Technical Service Bulletin

MODEL(S) AFFECTED: Tennant T1, E5 and R3

SUBJECT: Belt pulley screw backing out (torque bond breaking loose) due to vibration and resulting in pulley assembly damage.

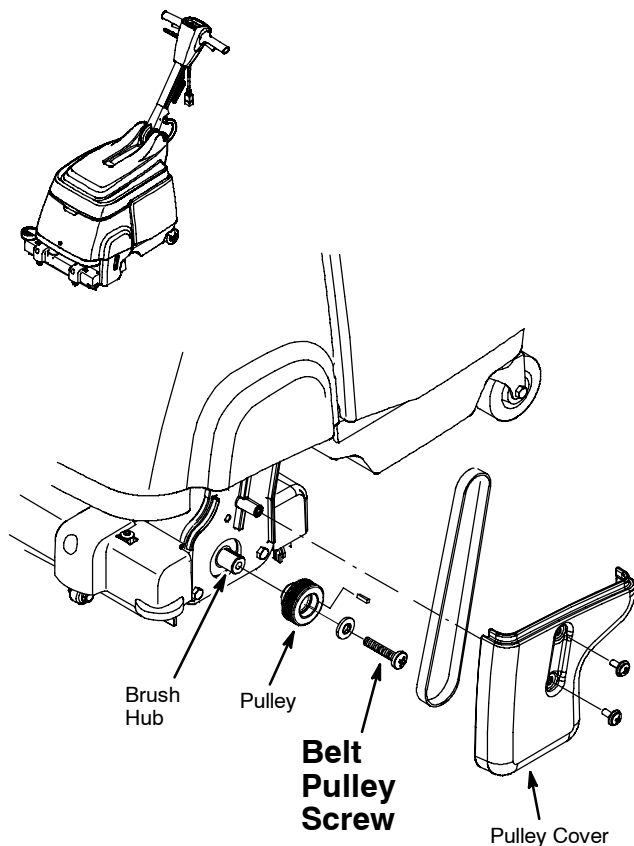
If the pulley assembly makes a grinding noise or abnormal sound, this is a good indication that the pulley screw has broken loose. The pulley cover will keep the screw from completely falling out and as a result may show signs of damage on the outside of the pulley cover where the screw presses against the cover.

PURPOSE: If pulley screw has broken loose and has not caused any damage to the pulley assembly, install the following service kits to prevent potential machine damage. *NOTE: Do not tighten pulley screw on machines that have not experienced this issue, you may break the torque bond.*
